SERVICE BULLETIN

B-064

Safety Recall Code 0831

P&A Accessory Tall Windscreen Part Nos. 58214-06Y and 58214-06YA

Figure 2. Mounting Hardware for Tall Windscreen

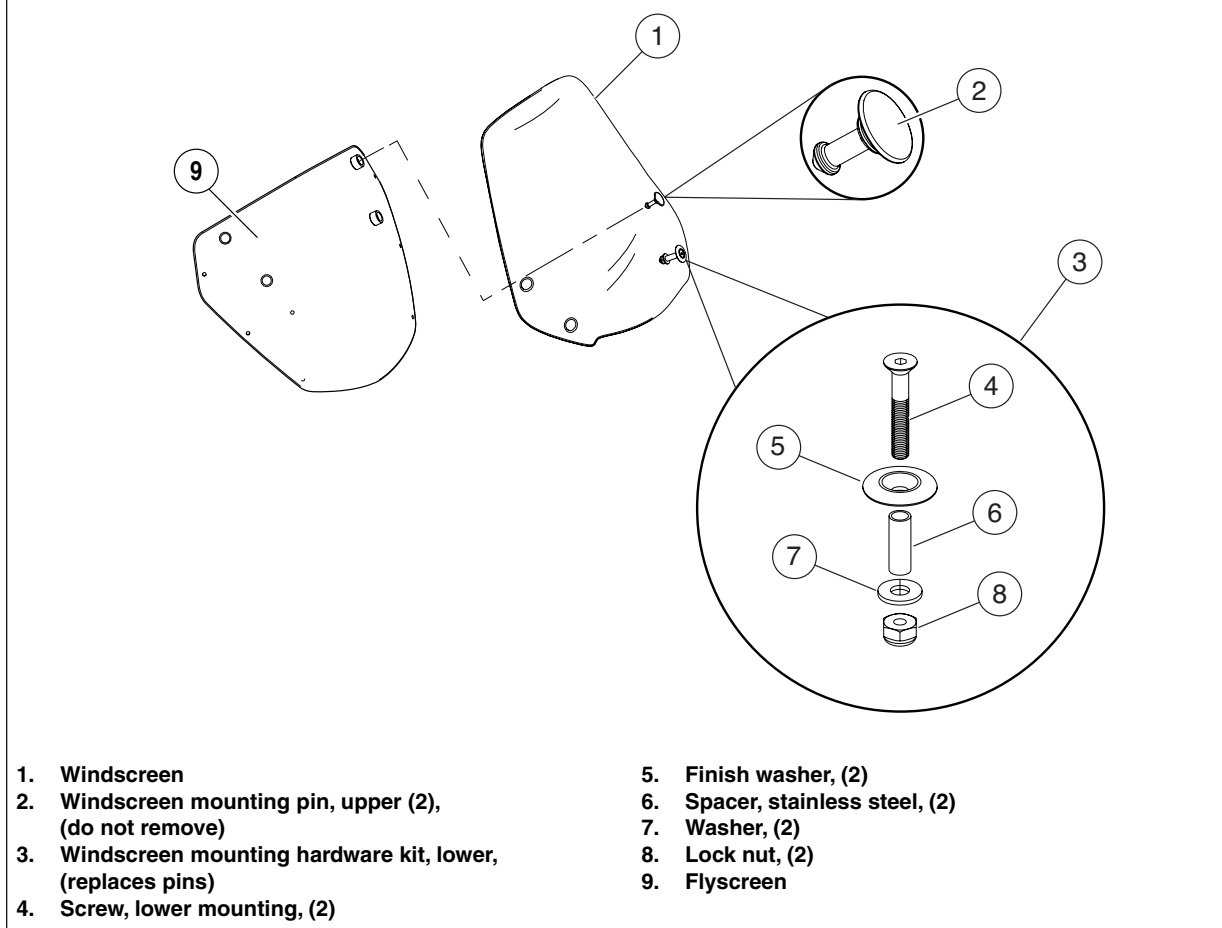
See Figure 2. The windscreen (1) upper mounting locations use mounting pins (2) (Factory installed in windscreen) and the lower two mounting locations use fasteners (3) supplied in the 94485Y recall kit. It will be necessary to remove the flyscreen in order to properly install the new windscreen lower fasteners.

- NOTE**
The windscreen **MUST** be installed to the flyscreen while both components are off the motorcycle. The lower fasteners can not be installed if the flyscreen is left installed on the motorcycle.

1. With the windscreen face down on a clean soft surface and using pliers, grasp the shoulder area of one of the lower mounting pins and apply downward and back and forth pressure to force mounting pin through the hole in the windscreen. Repeat for other lower mounting pin. Discard pins.
2. Remove the six screws attaching the flyscreen to the vehicle and remove the flyscreen. Place the flyscreen face down on a clean soft surface to prevent scratching or damage.
5. From the inside of the flyscreen place washer (7) onto the screw (4) and thread lock nut (8) onto screw. Tighten screw to 50-60 **in-lbs** (5.6-6.8 Nm).
6. Install flyscreen (with windscreen attached) using 6 screws removed earlier. Tighten screws to 10-12 **in-lbs** (1.1-1.4 Nm).

3. See Figure 2. Install the windscreen (1) by pushing the upper mounting pins (2) into place. Ensure upper mounting pins on windscreen locate properly into upper mounting grommets of the flyscreen.

4. Align the lower flyscreen and windscreen mounting holes. For the left and right side lower mounting holes, insert finish washer (5) and spacer (6) onto the screw (4) and place through the windscreen holes and flyscreen grommets.
